ST. MICHAEL SUBDIVISION

APPLICATION NUMBER 2 DATE January 3, 2019

DETAIL SITE PLAN

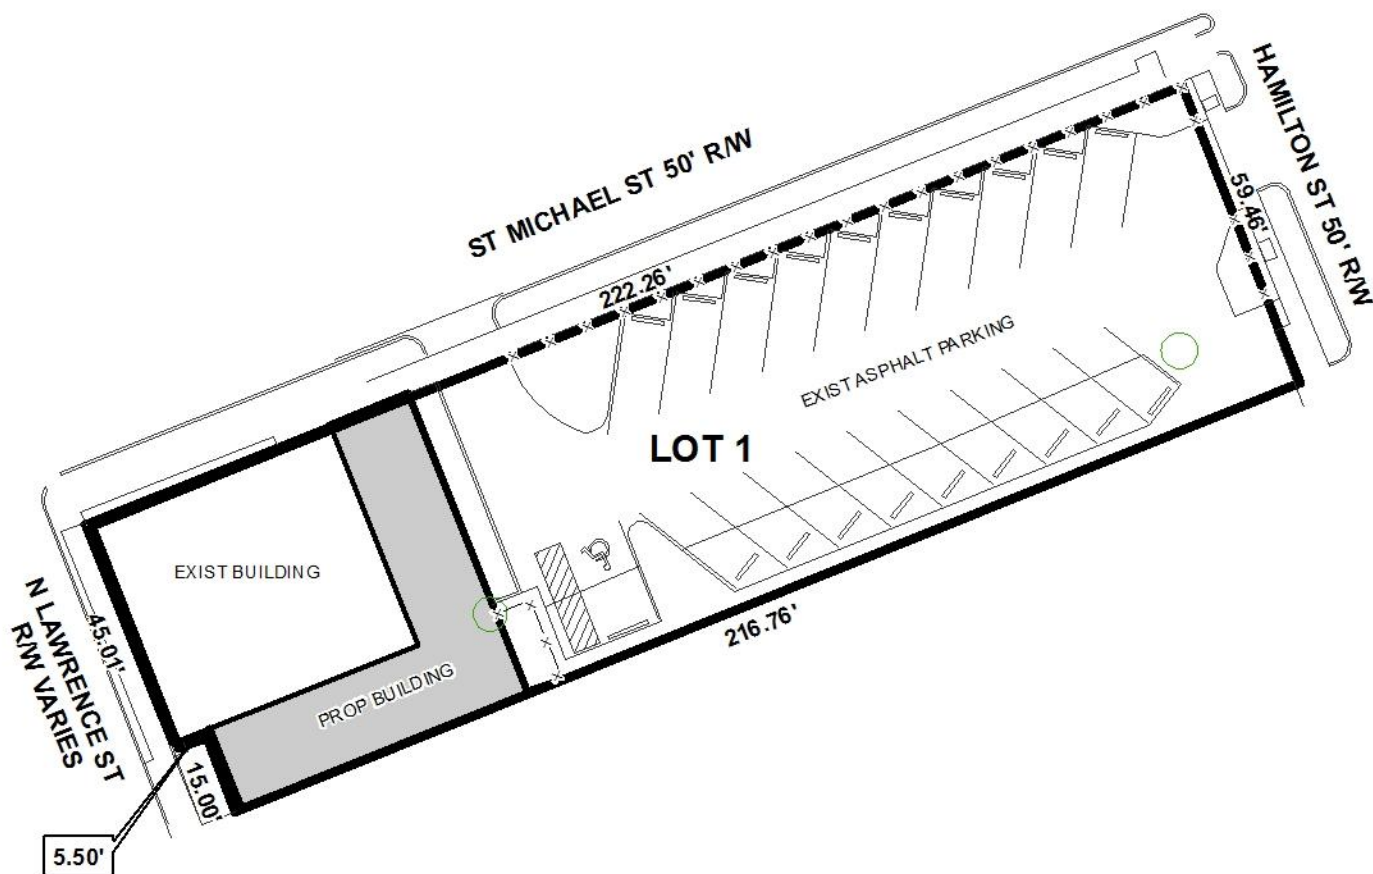
The proposed subdivision fronts St. Michael Street, North Hamilton Street and North Lawrence Street. A 50' right-of-way width is illustrated on the preliminary plat for St. Michael Street and if approved, should be retained on the Final Plat. The right-of-way widths of North Hamilton Street and North Lawrence Street are not illustrated on the preliminary plat. If approved, the right-of-way widths should be provided on the Final Plat.

There are no building setback lines illustrated on the preliminary plat. The DDD, per Section 64-3.I.8.(d), allows from 0' minimum to 12' maximum setback along all street frontages. If approved, the Final Plat should be revised to illustrate a 12' maximum building setback line along all street frontages, with a note stating a 0' minimum is allowed.

The DDD requires a parking setback to the rear of the façade for T-5.1 Sub-districts per Section 64-3.I.8.(d) of the DDD code. If approved, a note should be placed on the Final Plat indicating that a parking setback of at least the building setback is required.

The proposed lots meet the 7,200 square foot minimum lot size requirements of Section V.D.2. of the Subdivision Regulations for lots served by public water and sanitary sewer systems. The preliminary plat does not provide the lot size in square feet and in acres, but the proposed lot appears to exceed 7,200 square feet. If approved, the lot size information should be provided in square feet and acres on the Final Plat. However, it should be noted that there is no minimum lot area requirement for lots within the DDD.

- 1) Retention of the 50' right-of-way width to St. Michael Street;
- 2) Provision of the right-of-way widths to North Hamilton Street and North Lawrence Street;

- 3) Illustration of a 12' maximum building setback line along all street frontages, with a note stating that 0' minimum building setback is allowed;
- 4) Placement of a note stating that a parking setback of at least the building setback is required;

- 5) Provision of lot size information in both square feet and acres;
- 6) Compliance with Traffic Engineering comments and placement of a note on the Final Plat stating that the lot is limited to one curb cut per street frontage, with size, location and design to be approved by Traffic Engineering and conform to AASHTO standards;
